Application for Licence Amendment

Licence Number	L4680/1988/13
Licence Holder	FMR Investments Pty Ltd
ACN	009 411 349
File Number	2013/003899-1~13
Premises	Greenfields Processing Site Greta Eastern Highway COOLGARIE WA 6429 Legal description – Part of mining tenement M15/1836 and Lot 102 on Plan 40393 As defined by the Premises maps attached to the Revised Licence
Date of Report	03 November 2023
Decision	Revised licence granted

Figure 1: Standing water level at MB401, MB402 and MB403

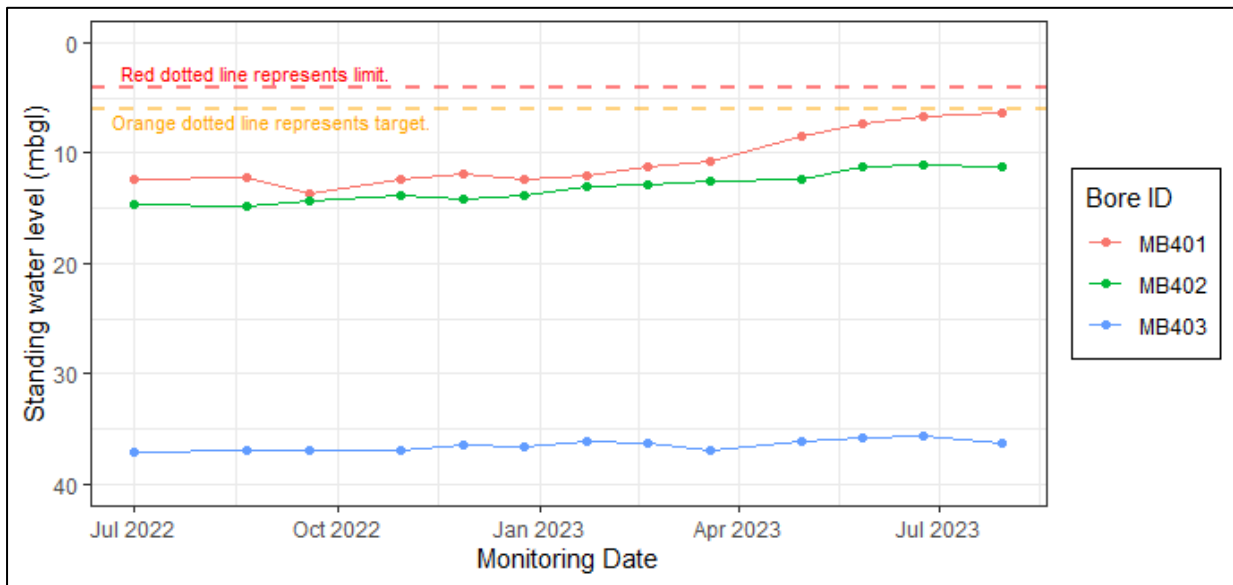
- Standing water levels (SWL) of MB401 and MB402 were relatively shallow, ranging between 6.3 mbgl and 14.8 mbgl (Figure 1). Groundwater is deeper at MB403, encountered 35.7 mbgl and 37.2 mbgl. Groundwater monitoring data appears consistent with depth of water strike at the time of bore advancement.

- Standing water levels at all three monitoring bores appeared to be rising at varying rates. The shallowest groundwater was observed at MB401, increasing from 12.4 mbgl (July 2022) to 6.3 mbgl (July 2023), representing an approximate rise of 6 m within the previous annual period (Figure 1). Rate of SWL rise has been lower at the other monitoring bores, increasing by approximately 3 m and 1 m at MB402 and MB403, respectively.

Figure 2: Water quality at MB401, MB402 and MB403

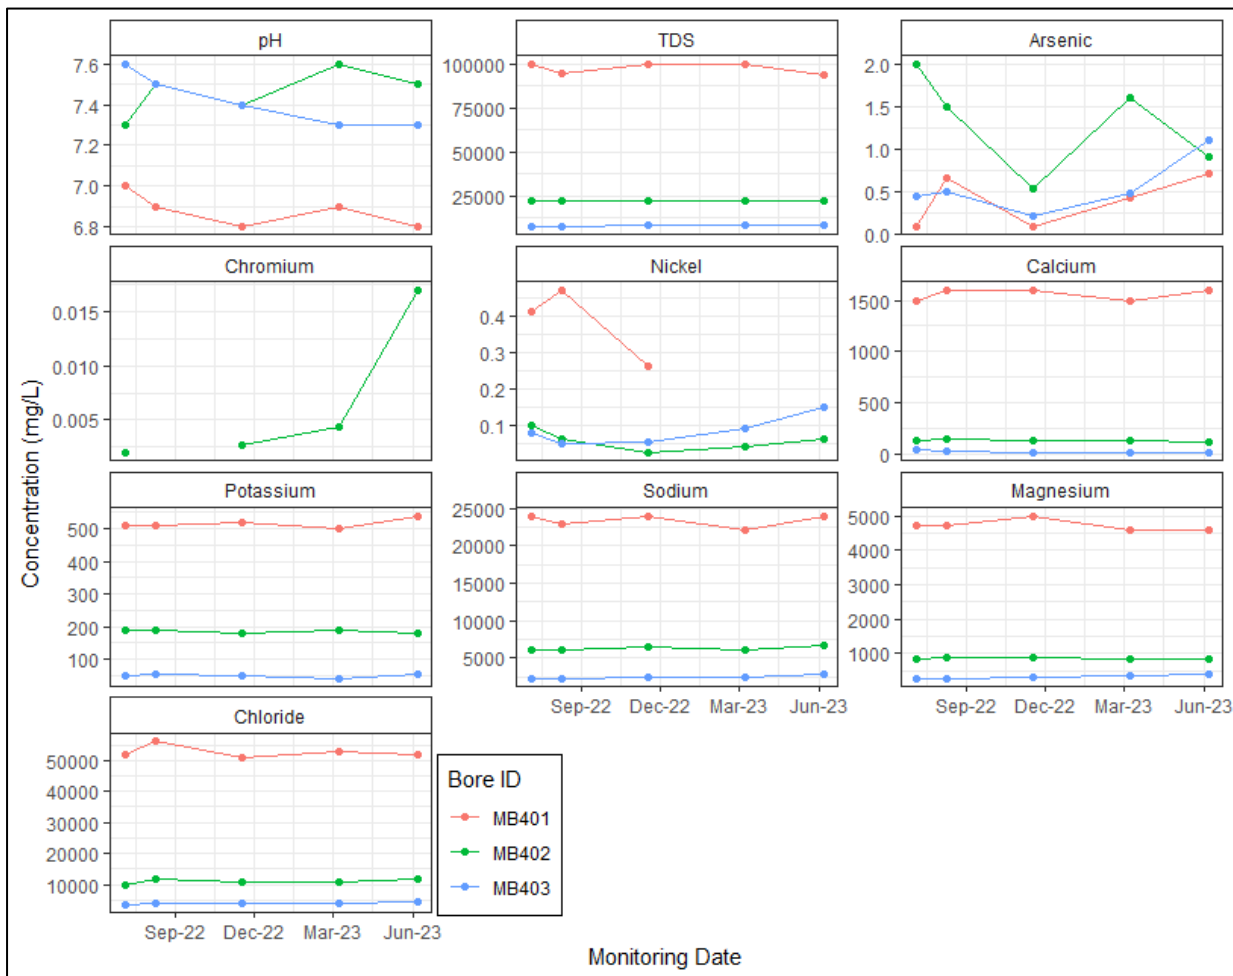
- Groundwater quality varied between the three groundwater monitoring bores (Figure 2). Generally, MB401 contained significantly higher total dissolved solids (TDS) and major ions (i.e., calcium, potassium, sodium, magnesium, chloride). Monitoring bores MB402 and MB403 contained similar concentrations of TDS and major ions, though concentrations in MB402 were slightly higher. The concentrations and trends observed were consistent with baseline monitoring undertaken prior to the time limited operation of TSF4, as required by works approval 6547/20221/1.
